SUBJECT: OCONEE NUCLEAR STATION, UNITS 1, 2, AND 3 - STAFF ASSESSMENT OF INFORMATION PROVIDED PURSUANT TO TITLE 10 OF THE *CODE OF FEDERAL REGULATIONS* PART 50, SECTION 50.54(f), SEISMIC HAZARD REEVALUATIONS FOR RECOMMENDATION 2.1 OF THE NEAR-TERM TASK FORCE REVIEW OF INSIGHTS FROM THE FUKUSHIMA DAI-ICHI ACCIDENT (TAC NOS. MF3736, MF3737, AND MF3738)

STAFF ASSESSMENT BY THE OFFICE OF NUCLEAR REACTOR REGULATION

RELATED TO SEISMIC HAZARD AND SCREENING REPORT

OCONEE NUCLEAR STATION, UNIT NOS. 1, 2, AND 3

Figure 3.2-1 Plot Comparing the Staff's and the Licensee's Mean Control Point Hazard Curves at a Variety of Frequencies for the Oconee Site. RAI Response Curves are Licensee Curves Developed using the Currently Endorsed CEUS-SSC (NUREG-2115) for the Oconee Site

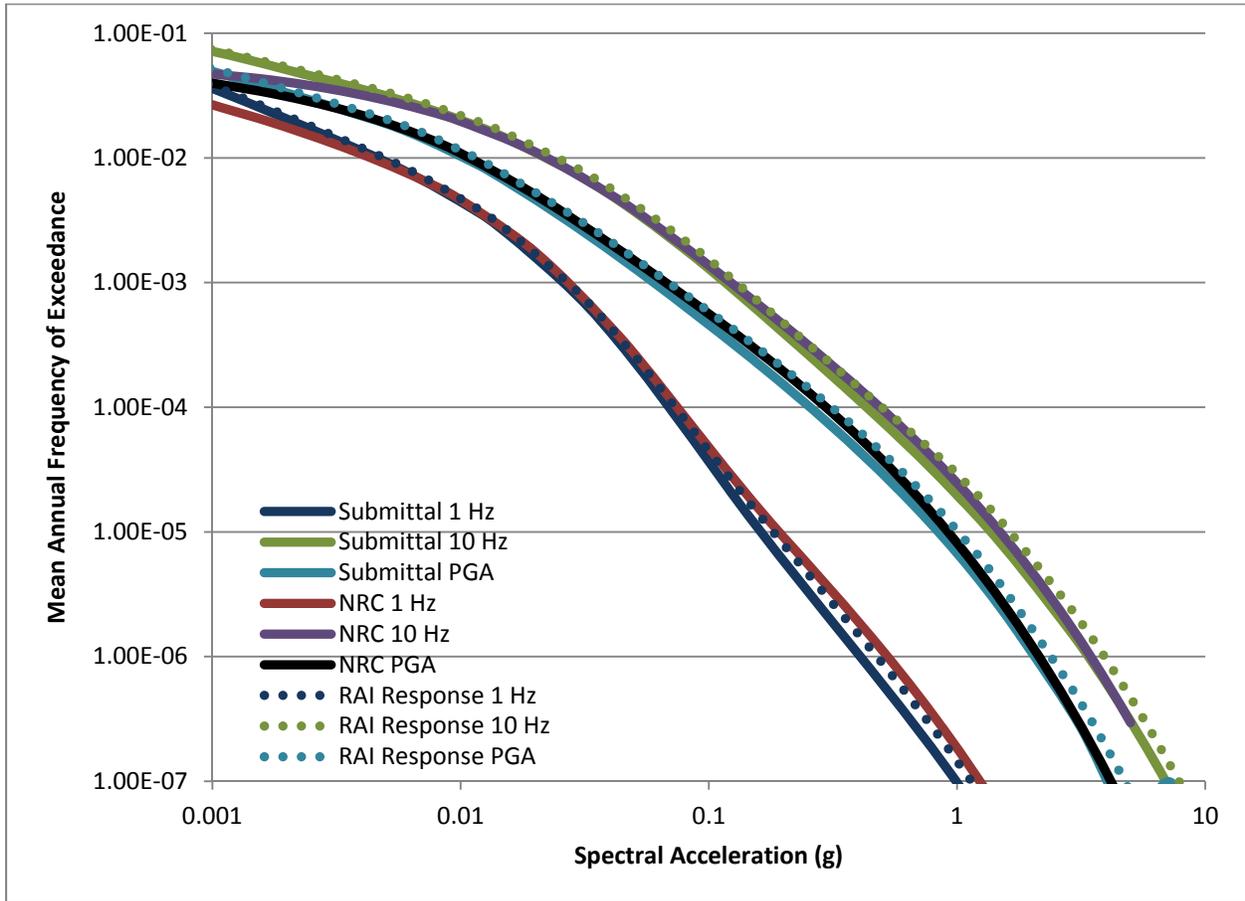
As part of its RAI response, the licensee provided base rock hazard curves in order to show the impact of its refinements to the CEUS-SSC seismicity catalog. Figure 3.2-1 of this assessment shows the licensee's base rock hazard curves along the staff's base rock hazard curves. As shown in Figure 3.2-1 of this assessment, the impact of the licensee's changes to the hazard inputs have a very minor impact on the hazard for the Oconee site.

Figure 3.3-1 Plot of Staff's and Licensee's Base Case Shear-Wave Velocity Profiles for the Oconee site

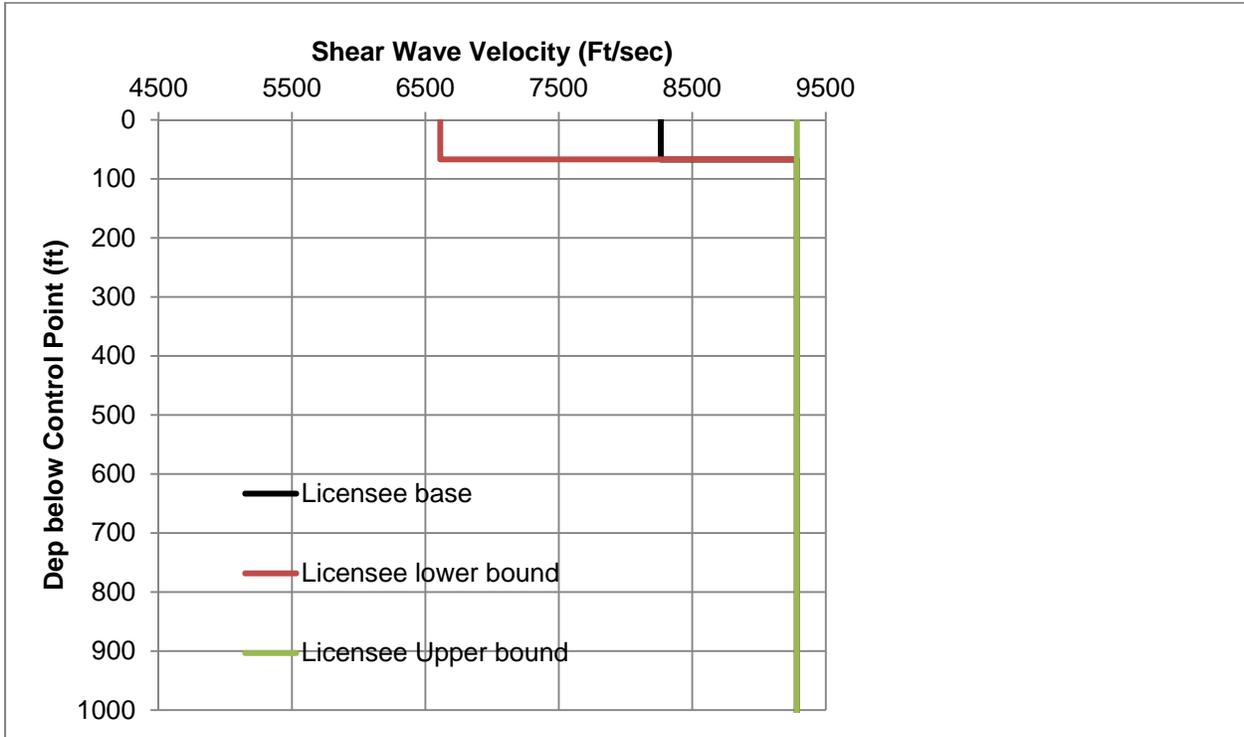
To characterize the subsurface geology, the licensee developed three site base case profiles. The licensee's middle, or best estimate profile was developed using measured the shear-wave velocity of 8,265 fps [2,519 m/sec] from the MSIV project and assumed to be constant over the 67 ft [20.4 m] of firm rock. The licensee developed upper and lower base case profiles using a natural log standard deviation of 0.20. As such, the lower velocity profile has a constant S-wave velocity of 6,612 fps [2,015 m/sec] and since the S-wave velocity for the upper velocity profile exceeds the assumed base rock velocity of 9,285 fps [2,830 m/sec], the licensee concluded that the upper profile should be considered as hard base rock. Figure 3.3-1 of this assessment shows the licensee's three shear-wave velocity base case profiles.

The licensee used the latest geotechnical exploration data to establish the shear wave velocity profile for the site, which was based on three boreholes with shear wave velocity measurements (P-S logging) at the distance between 19.5 and 28 ft [5.9 to 8.5 m] to the edge of the three reactor units. Because the site profile established based on some recent obtained and site-specific data and is fairly well characterized, the NRC staff used the same input velocity profiles as those provided by the licensee. Figure 3.3-1 of this staff assessment shows the velocity profiles used by the licensee and the staff.

Figure 3.3- 2 Plot Comparing the Staff's and the License's Median Amplification Functions and Uncertainties for two input loading levels for the Oconee site

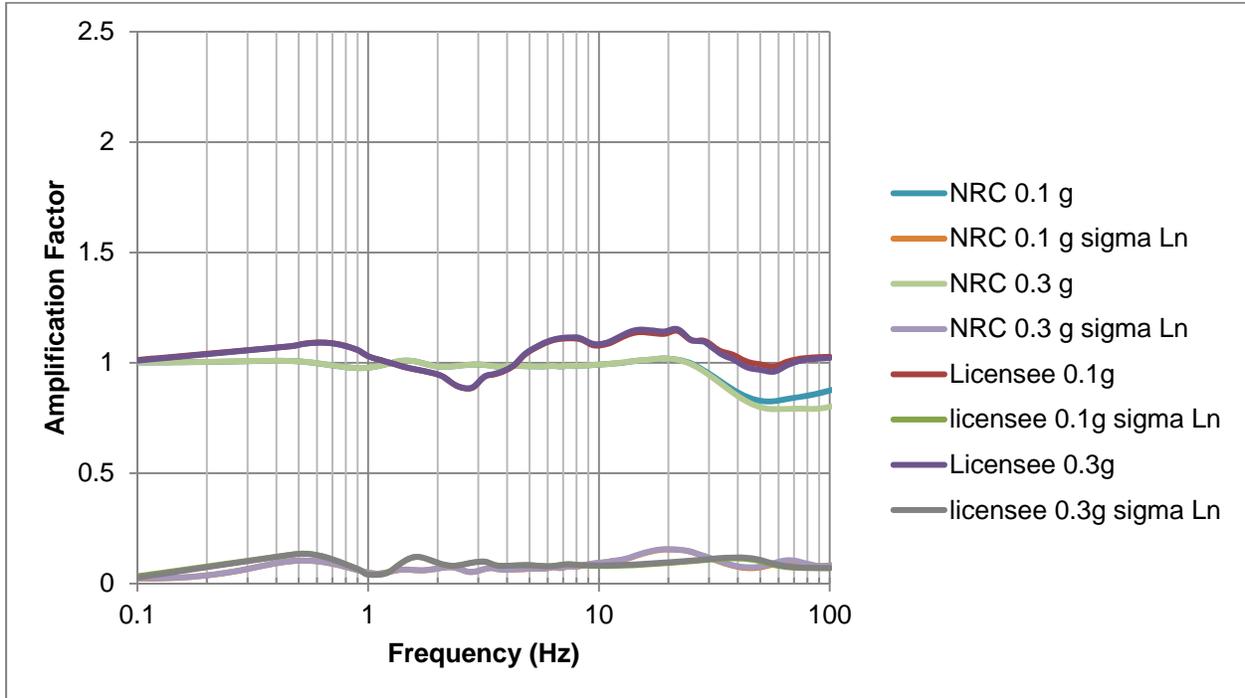
Figure 3.3-2 of this assessment shows a comparison of the staff's and licensee's median site amplification functions and uncertainties (± 1 standard deviation) for 2 of the 11 input loading

levels. Due to the use of very low damping values and modeling of the rock behavior as essentially linear for the range of input loading levels, the NRC staff's confirmatory amplification factors are essentially one for the entire frequency range. The licensee's amplification functions are also flat over the entire frequency range for the two loading levels shown in the SHSR.

Figure 3.3-3 Plot Comparing the Staff's and the Licensee's Mean Control Point Hazard Curves at a Variety of Frequencies for the Oconee site

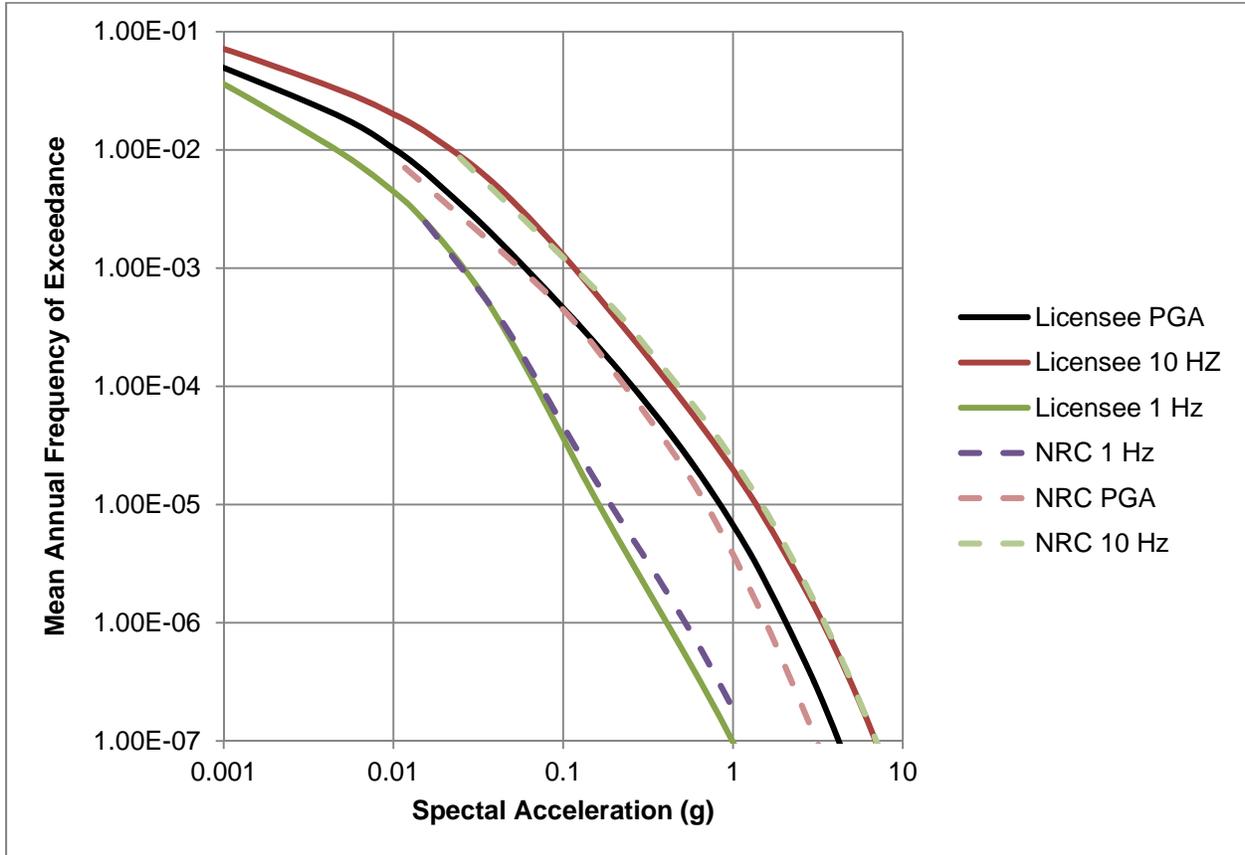
Overall, the licensee's approach to modeling the subsurface rock properties and their uncertainty, results in very similar amplification factors as those developed by the staff. In addition, as shown in Figure 3.3-3 of this assessment, the NRC staff's and licensee's control point seismic hazard curves are very similar.

Figure 3.4-1 Comparison of the Staff's GMRS with Licensee's GMRS and the SSE for the Oconee site

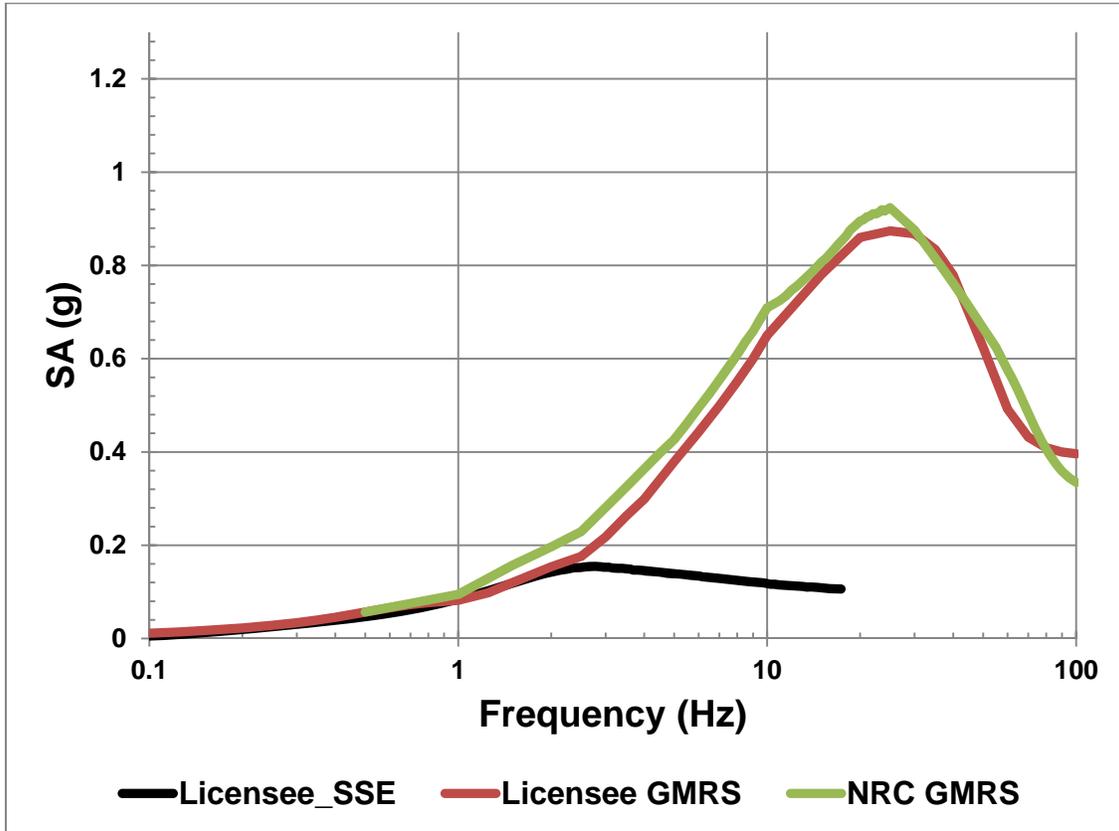
The NRC staff independently calculated the 10^{-4} and 10^{-5} UHRS using the results of its confirmatory PSHA and site response analyses, as described in Sections 3.2 and 3.3 of this staff assessment, respectively. Figure 3.4-1 of this assessment shows a comparison of the GMRS determined by the licensee to that determined by the NRC staff.

The NRC staff confirms that the licensee used the present-day guidance and methodology outlined in RG 1.208 and the SPID to calculate the horizontal GMRS, as requested in the 50.54(f) letter. The NRC staff performed both a PSHA and site response confirmatory analysis and achieved results consistent with the licensee's horizontal GMRS. As such, the NRC staff concludes that the GMRS determined by the licensee adequately characterizes the reevaluated hazard for the Oconee site. Therefore, this GMRS is suitable for use in subsequent evaluations and confirmations, as needed, for the response to the 50.54(f) letter.
